DEVELOPMENT ASSESSMENT REPORT			
Application No.	MOD/2023/0137		
Address	4 Caroline Street BALMAIN NSW 2041		
Proposal	Modification to approved works inclusive of the following: deletion of deferred commencement condition relating to car access to lane and carstacker, changes to internal layout, new pool, new basement home theatre and utility room, changes to external works.		
Date of Lodgement	20 May 2023		
Applicant	Landmark Investments Australia Pty Ltd		
Owner	Landmark Investments Australia Pty Ltd		
Number of Submissions	12 plus petition with 27 signatures		
Value of works	\$2,000,000.00		
Reason for determination at Planning Panel	Number of submissions		
Main Issues	Vehicle use of Jaggars Lane		
Recommendation	Approved with Conditions		
Attachment A	Recommended conditions of consent to be modified		
Attachment B	Notice of Determination DA/2022/0322		
Attachment C	Plans of Proposed Modification

1. Executive Summary

Figure 3 – Swept Path

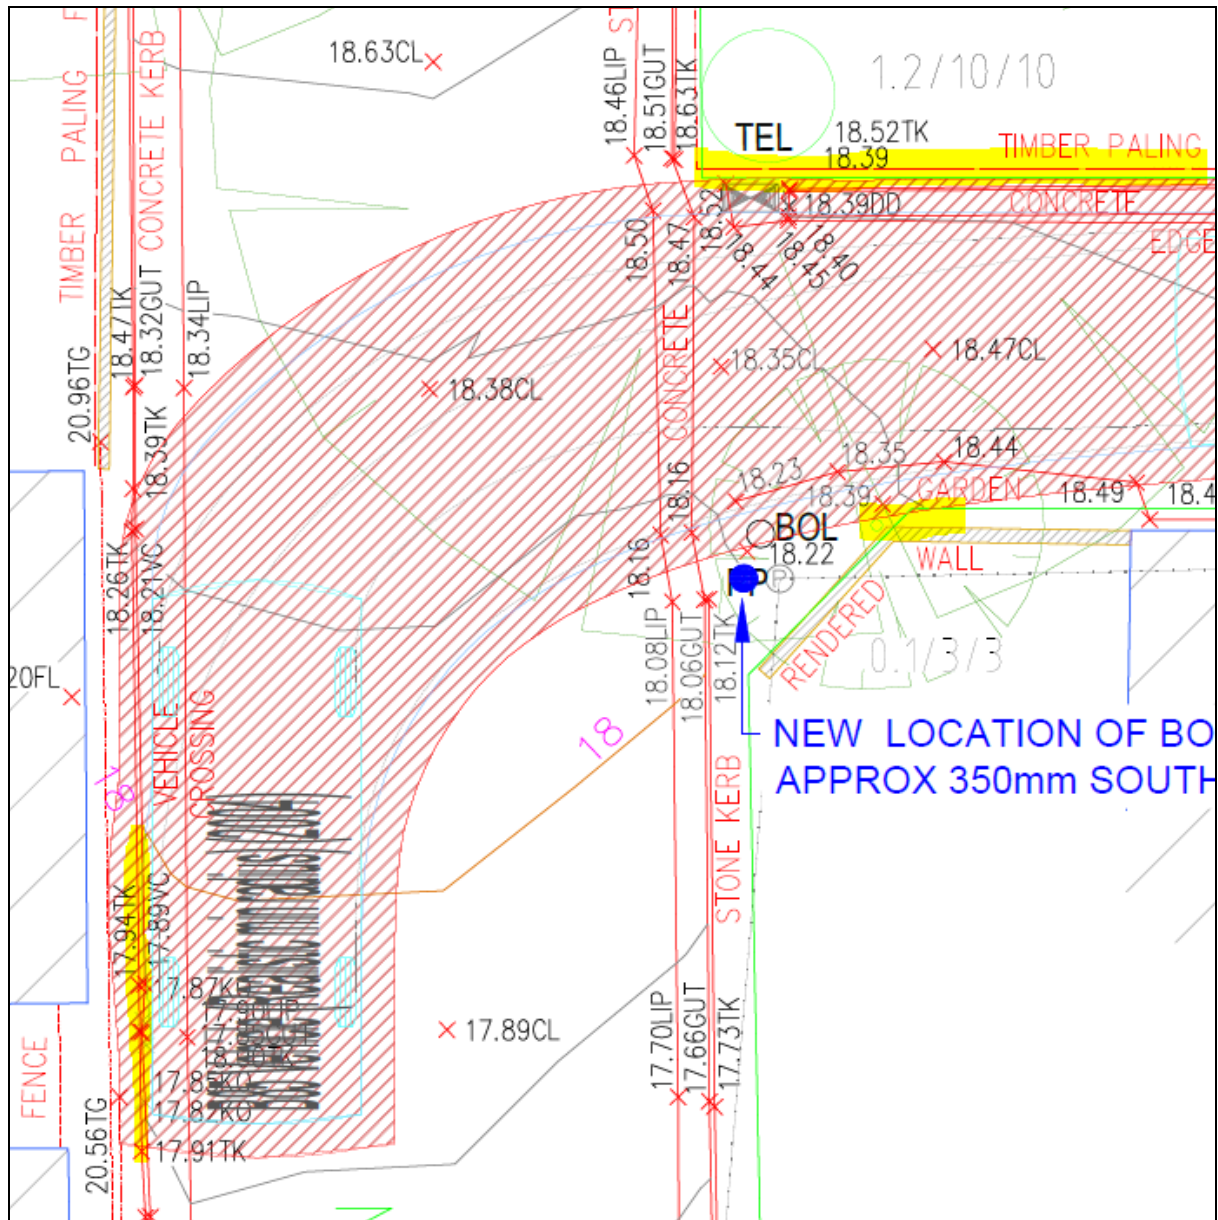
The swept paths provided show that if the bollard is relocated then B85 is able to enter the Lane. However, the manoeuvre is very difficult and requires precision driving every time a vehicle accesses the lane.

The swept paths below details how a vehicle is required to position itself hard up along the kerb line in Duncan Street then turn the steering wheel on full lock at the precise position shown on the swept paths below. If a vehicle makes the turn too early or too late then the manoeuvre cannot be made without the vehicle colliding with a boundary fence, tree or bollard. It should also be noted that the extremities of the swept paths at times encroach the property boundary (green line) in some instances.

For the reasons above vehicle access from Jaggars Lane is again not supported. In addition, the proposed deletion of Deferred Commencement Condition A is not supported. It is recommended that the applicant amend the plans as required by Deferred Commencement Condition A(ii) to delete the car space and car stacker from the plans.

Figures 4 & 5 – Further Swept Paths

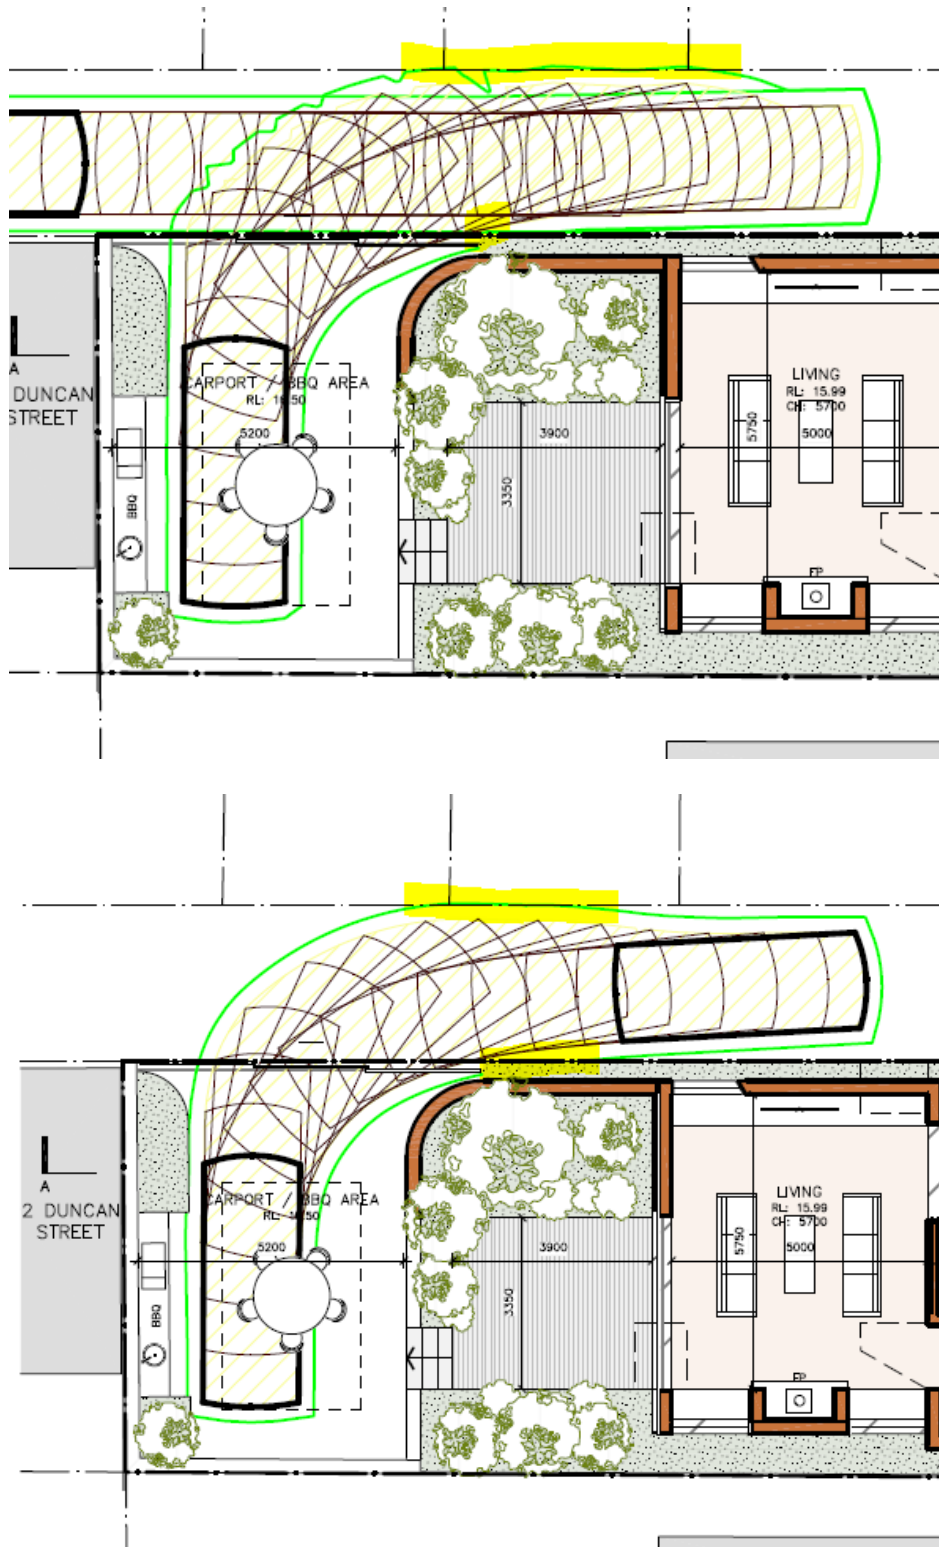
If a vehicle enters Jaggars Lane without incidence another very difficult manoeuvre is required to enter the property. Below are the swept paths that again detail the precise movements that are required to enter and leave the property. Again, the swept paths show that they encroach the property boundaries and any error will lead to vehicles colliding with boundary fences.
